Supplement

Application for Certification

Russell City Energy Center

01-AFC-7

Normal Flows Without NEE Project
 Commonwealth Associates, Inc.
 5 Jun 2001

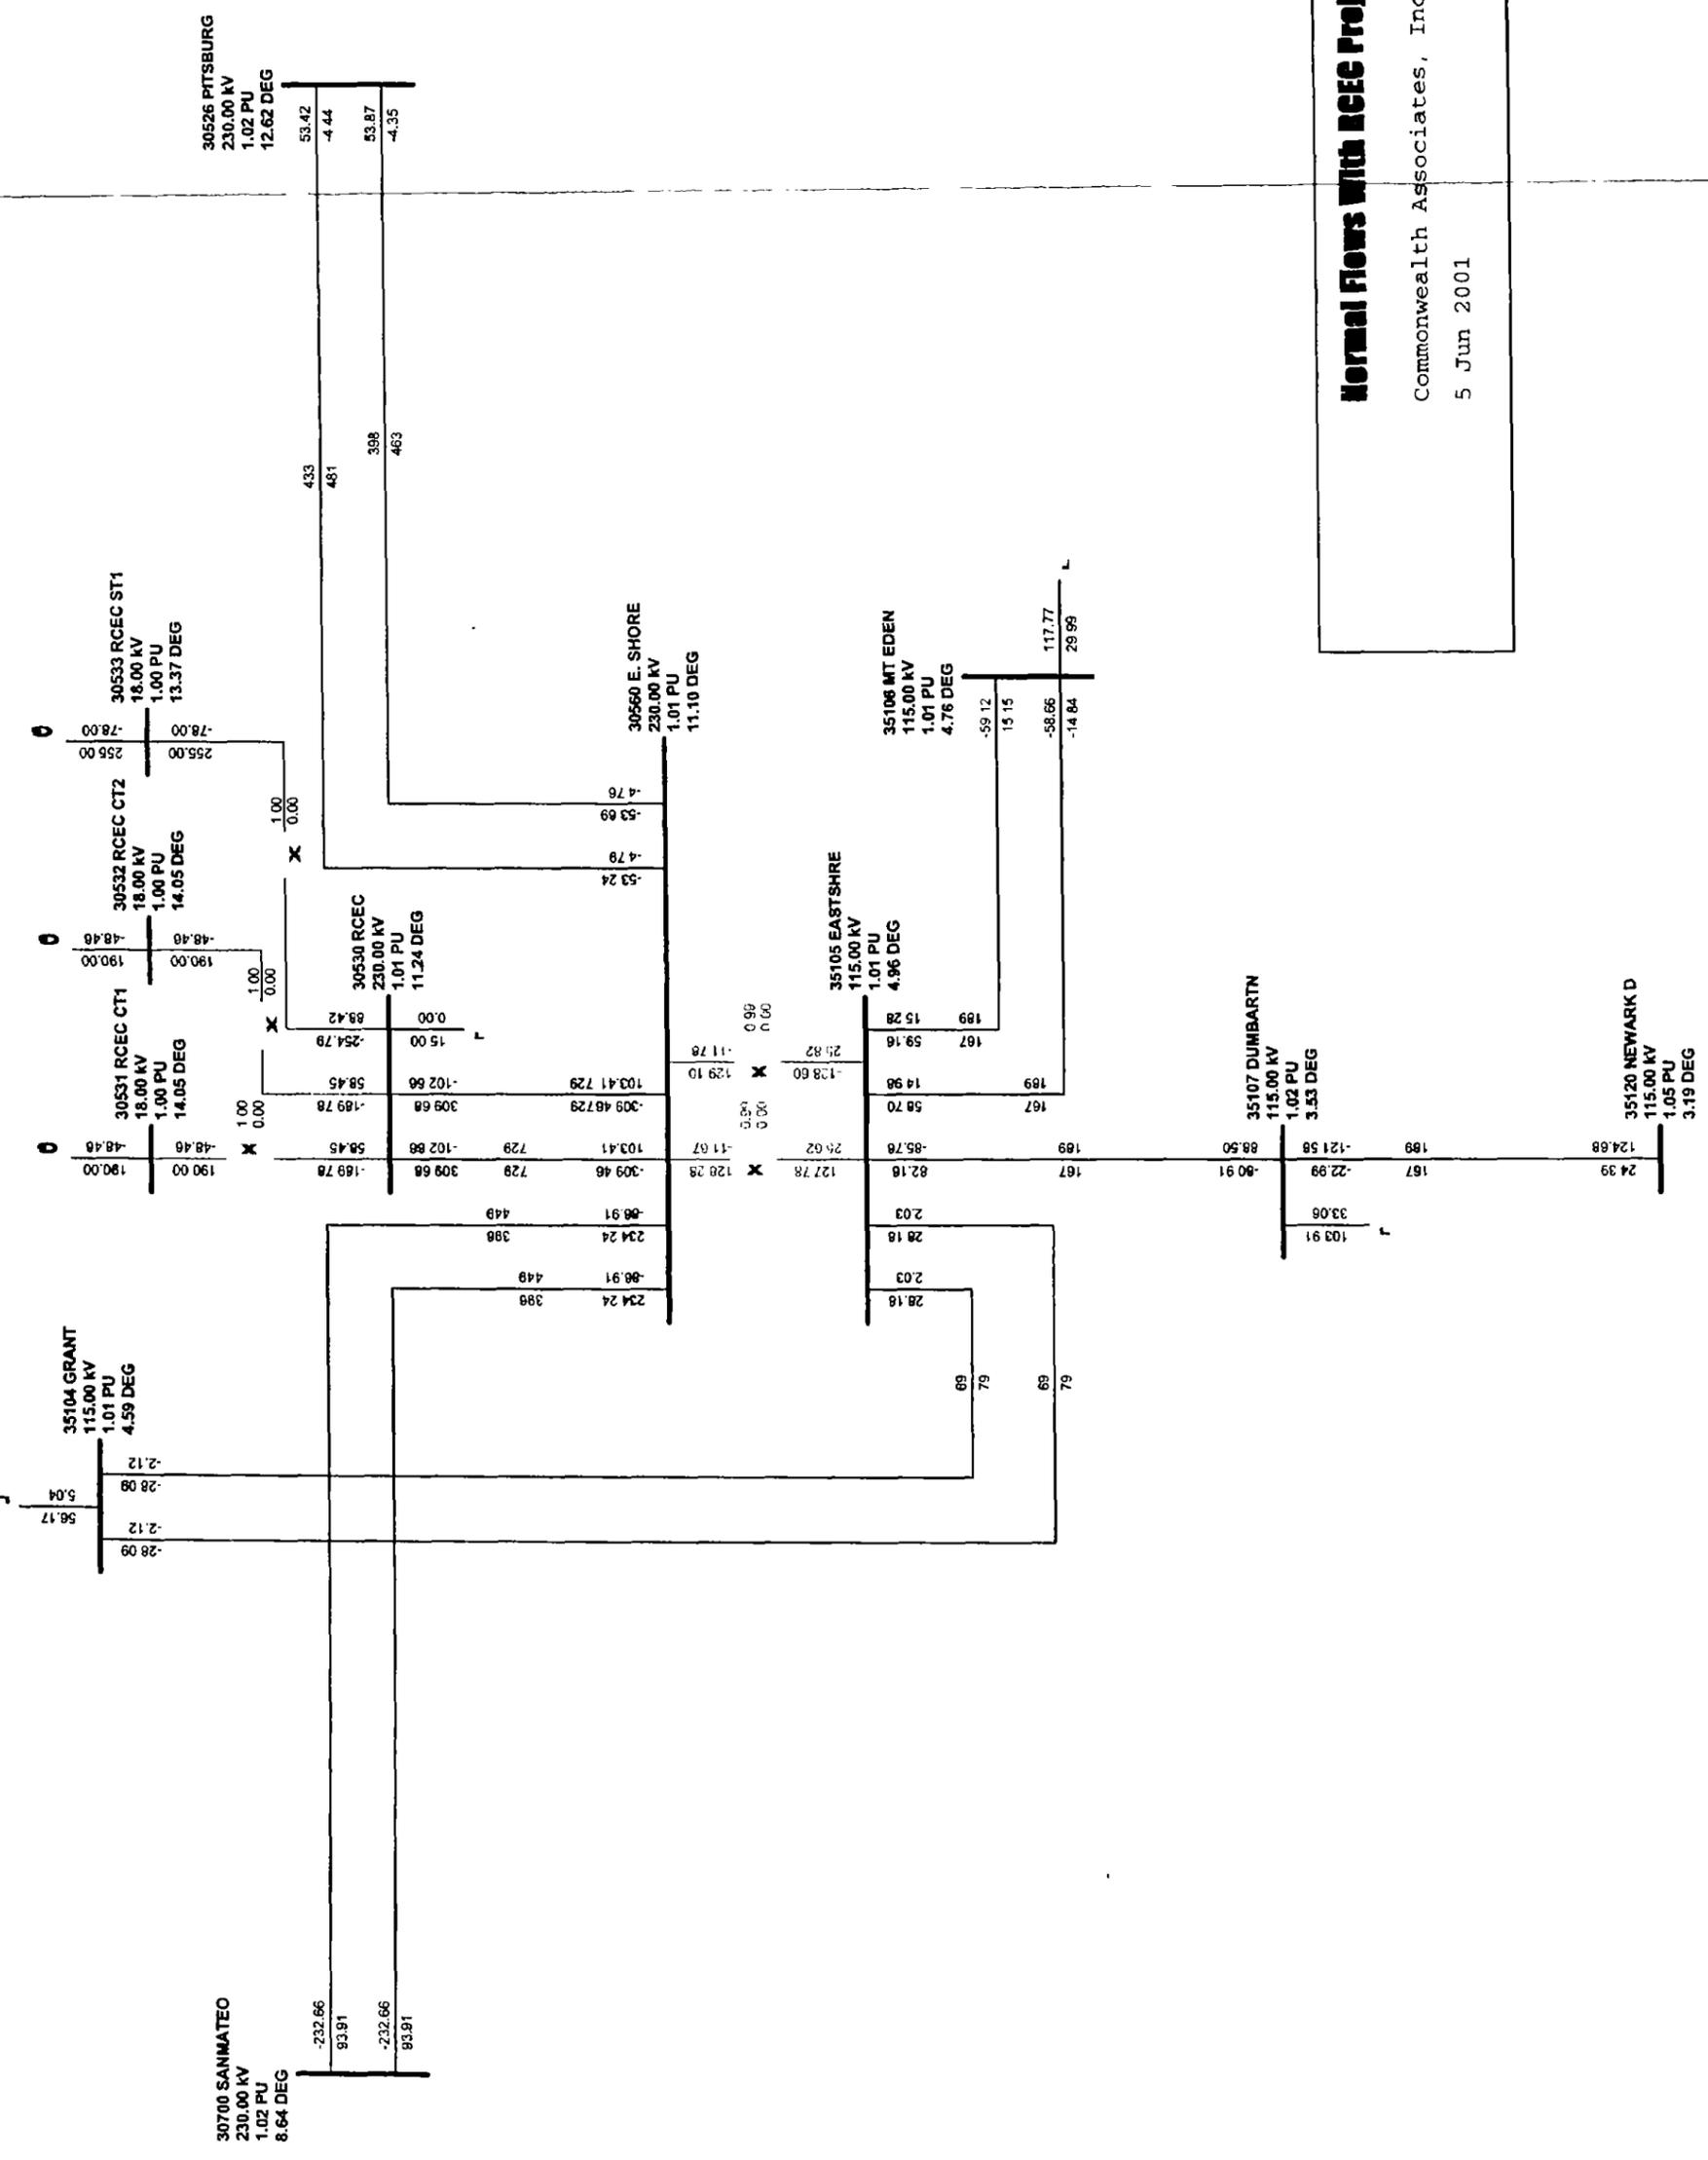
Provide power flow diagram for normal conditions, with and without the project, and for contingencies, which caused a criteria violation.

Provide power flow diagrams for normal conditions, with and without the project, and for contingencies, which caused a criteria violation.

Response—Power flow diagrams for normal conditions, with and without the project, are provided at the end of this section. We used the 996/1129 A ratings originally provided for the San Mateo-Eastshore line in the model rather than the ratings that may materialize from PG&E's ongoing assessment. These will be updated as information becomes available.

Figure 8.15(s)-3b

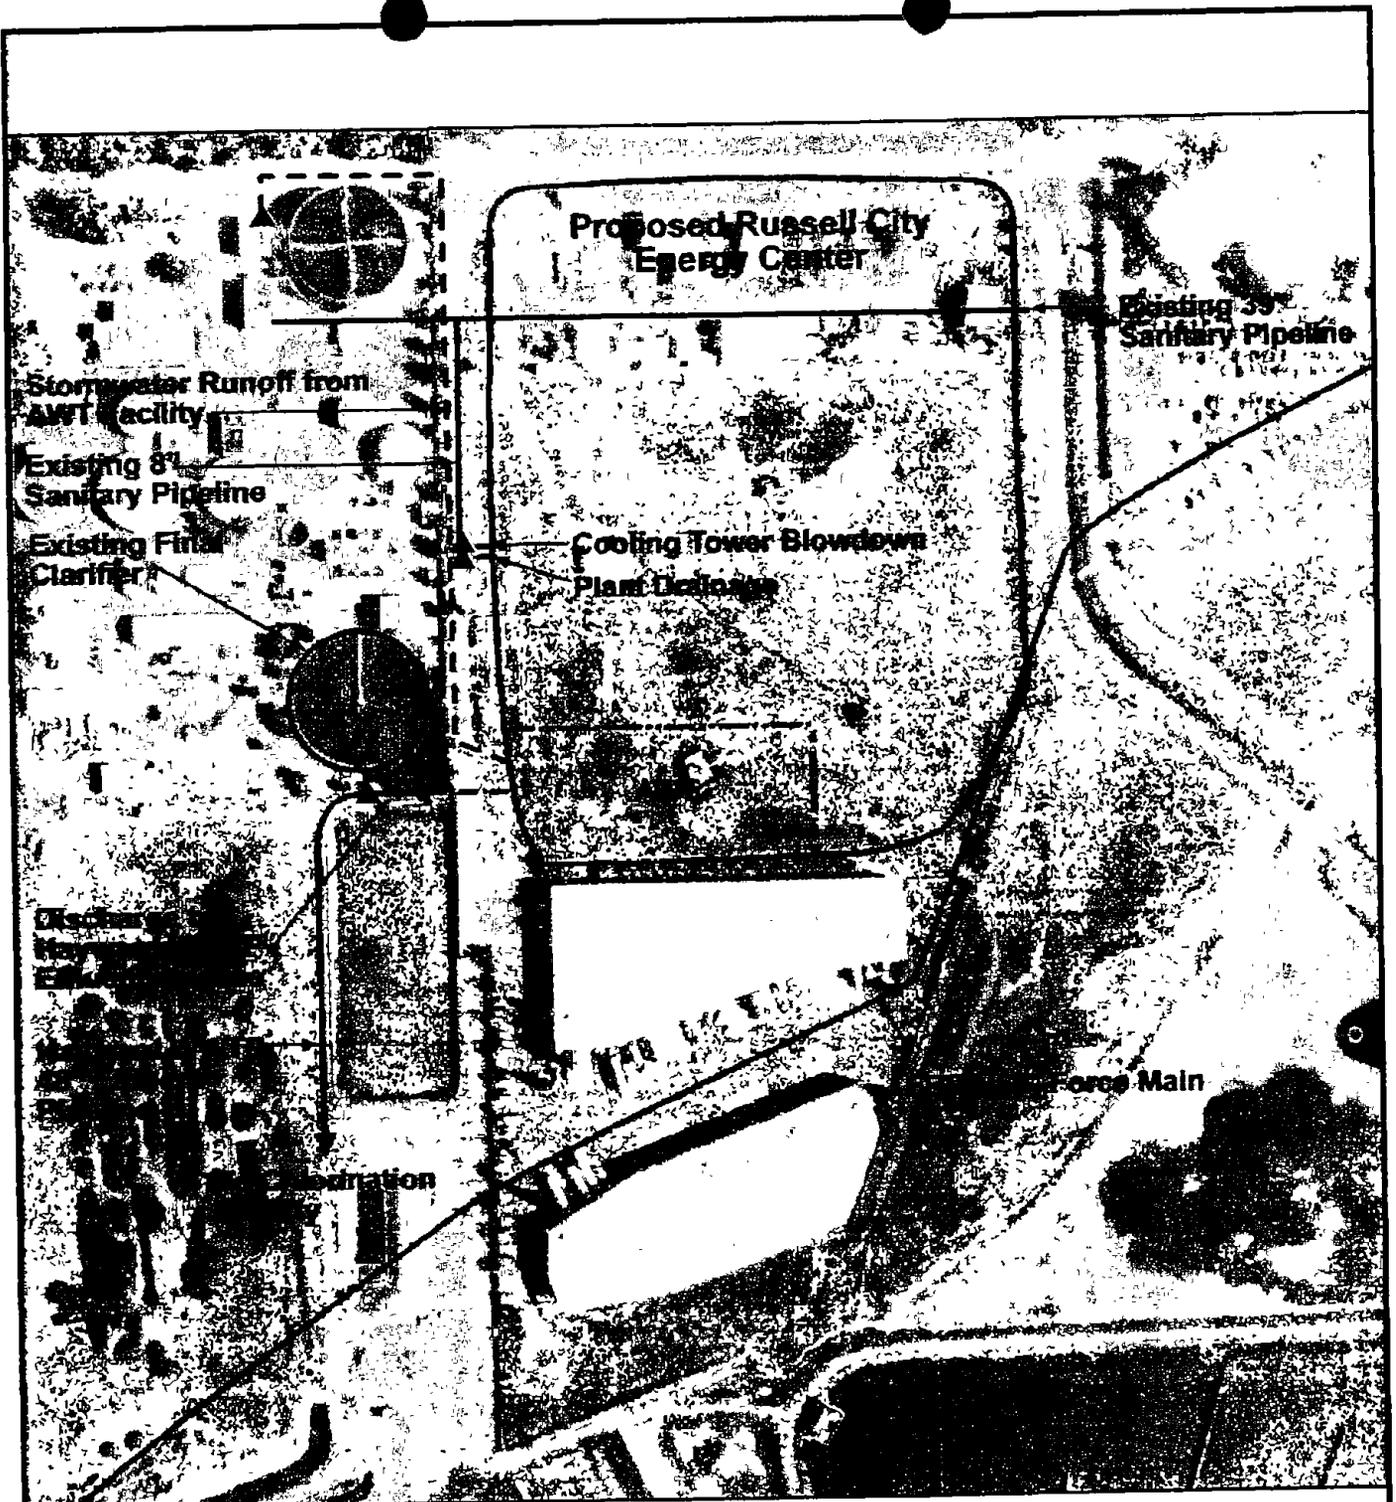
Energy Commission staff finds Figure 2.3-2 (Water Pipeline Routes) to be confusing. Please provide legible drawings that show clear connection points and routes for the different water lines. Staff recommends the use of a mapping symbols legend to avoid plan congestion.

Response—To simplify Figure 2.3-2 the water supply and discharge pipelines have been placed on separate figures. Figures 2.3-2a (Water Supply Pipeline Routes) and 2.3-2b (Water Discharge Pipeline Routes) are included at the end of this section. Additionally, connection points to existing facilities are identified.
